RESOLUTION NO. 55-21

A RESOLUTION OF THE CITY COUNCIL OF THE CITY OF RICHMOND, CALIFORNIA, ADOPTING THE FINAL MITIGATED NEGATIVE DECLARATION AND MITIGATION MONITORING AND REPORTING PROGRAM FOR THE VIA VERDI SLOPE STABILIZATION PROJECT AND INITIATING AND AUTHORIZING THE CONSTRUCTION PHASE OF THE PROJECT

Response to Comments

REINFORCED CONCRETE CULVERT PLAN AND PROFILE

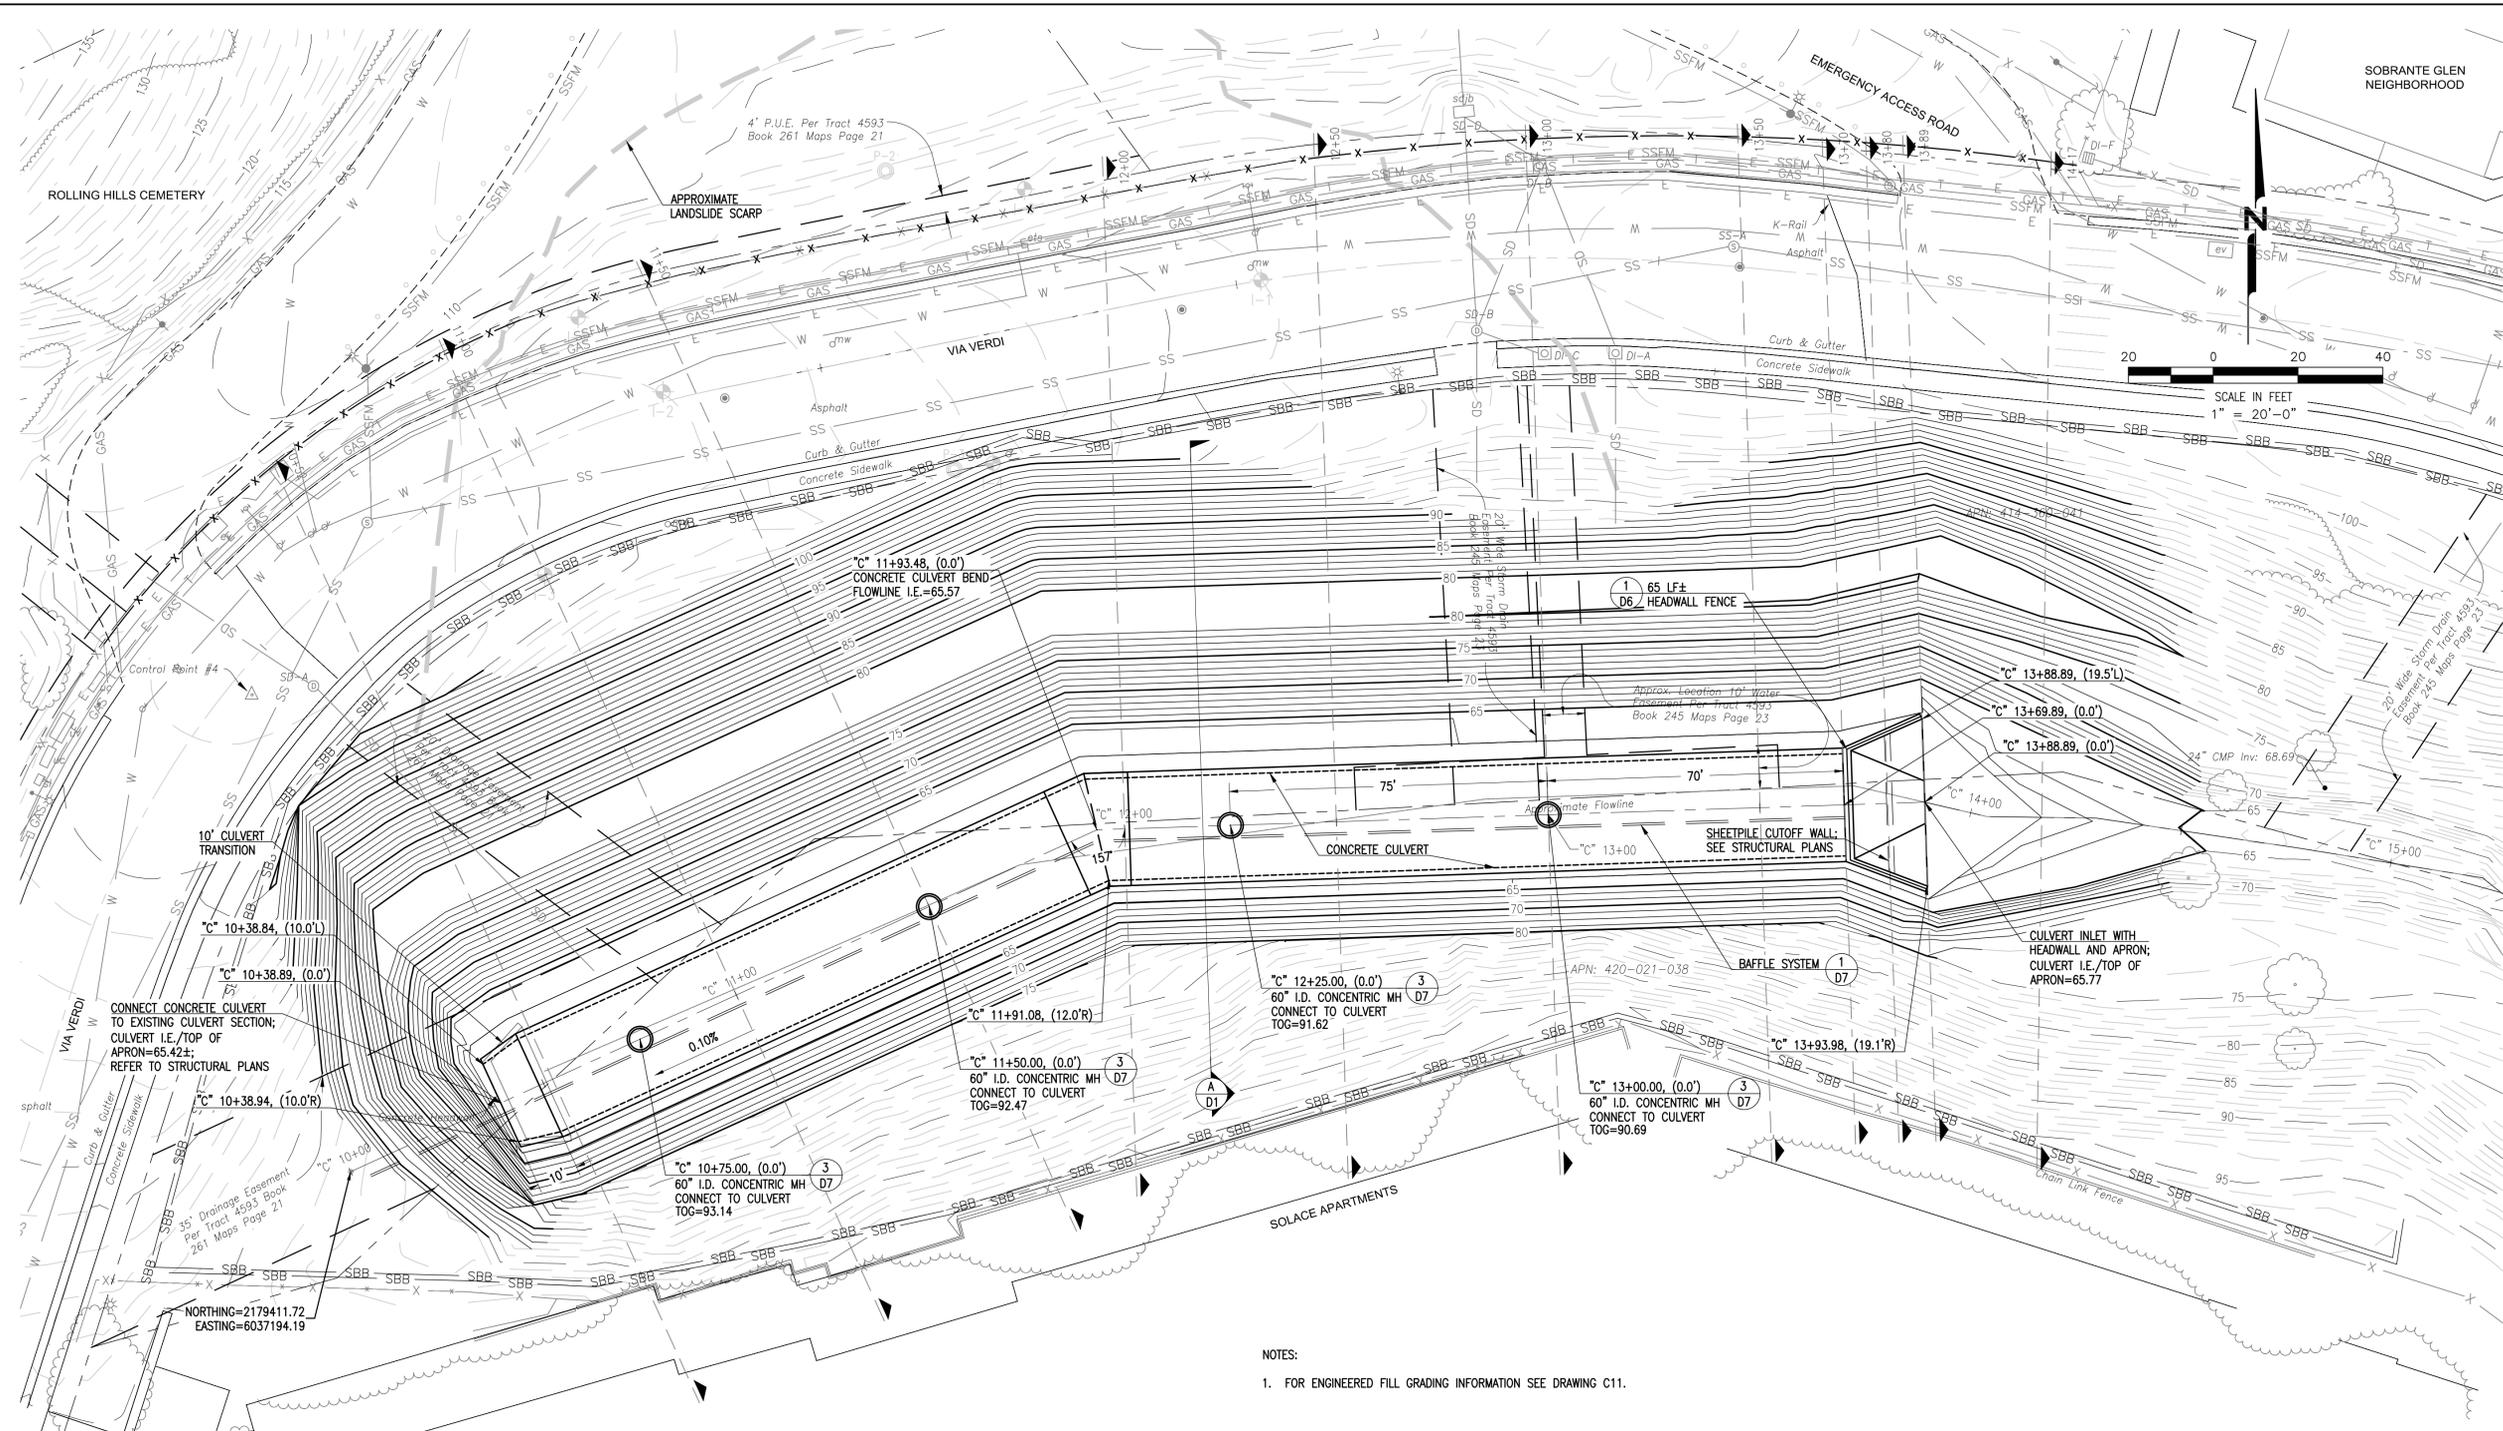
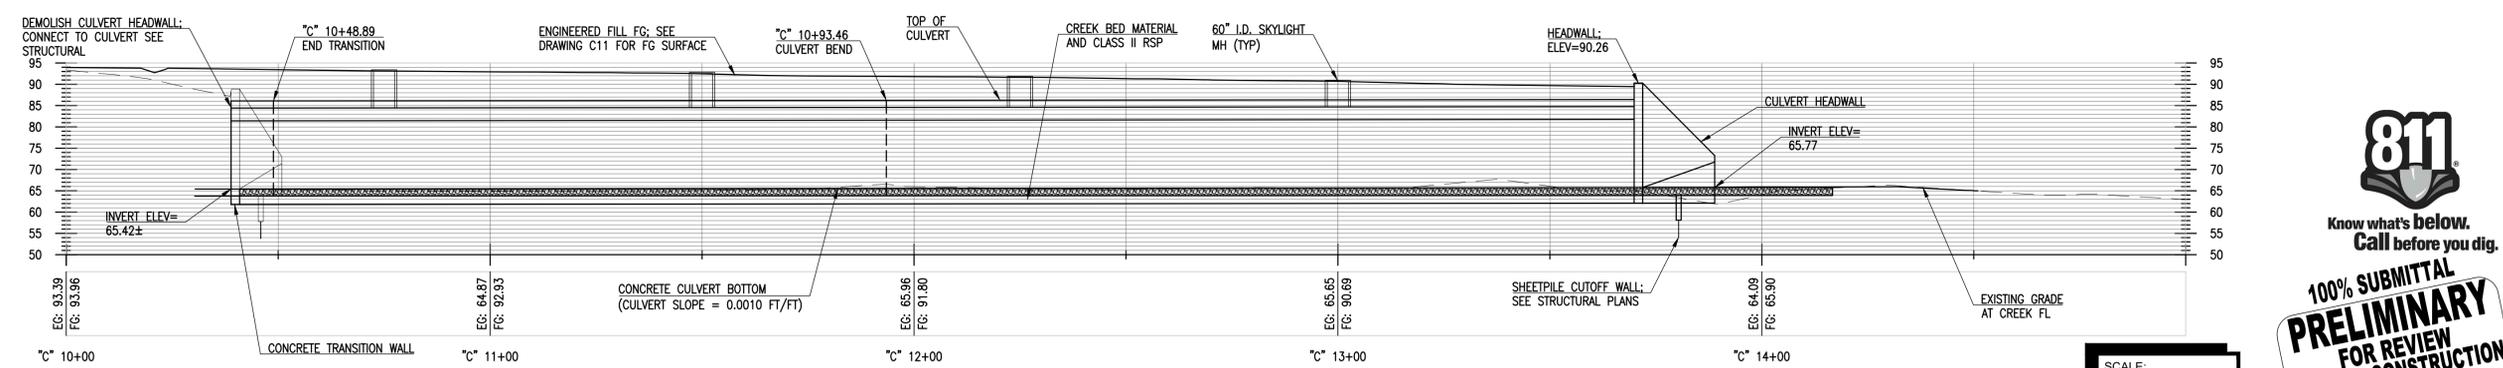
The 350 linear foot culvert within San Pablo Creek will be set within the creek channel aiming at establishing a creek bed within the culvert that allow movement of fish within and through the culvert to areas that provide both spawning habitat and riparian cover. To meet these habitat requirements fine gravel will be placed upstream of the culvert headwall to encourage the formation of breeding habitat for California Roach and Sacramento Suckers. The fine gravel will be placed for a total length of 50 feet within San Pablo Creek. This mirrors a recommendation from the San Pablo Creek 2010 study that due to the lack of suitable size spawning substrate within San Pablo Creek reaches, projects “should be designed at suitable sites to trap and sort spawning gravel” (California Department of Fish and Wildlife, Marin County 2013). The placement of spawning gravel in the shallow reaches upstream of the proposed culvert will meet this recommendation. In addition, upstream of the proposed culvert head and wing walls, willow brush mattresses will be installed to provide additional aquatic riparian cover to reduce predation of threespine stickleback.
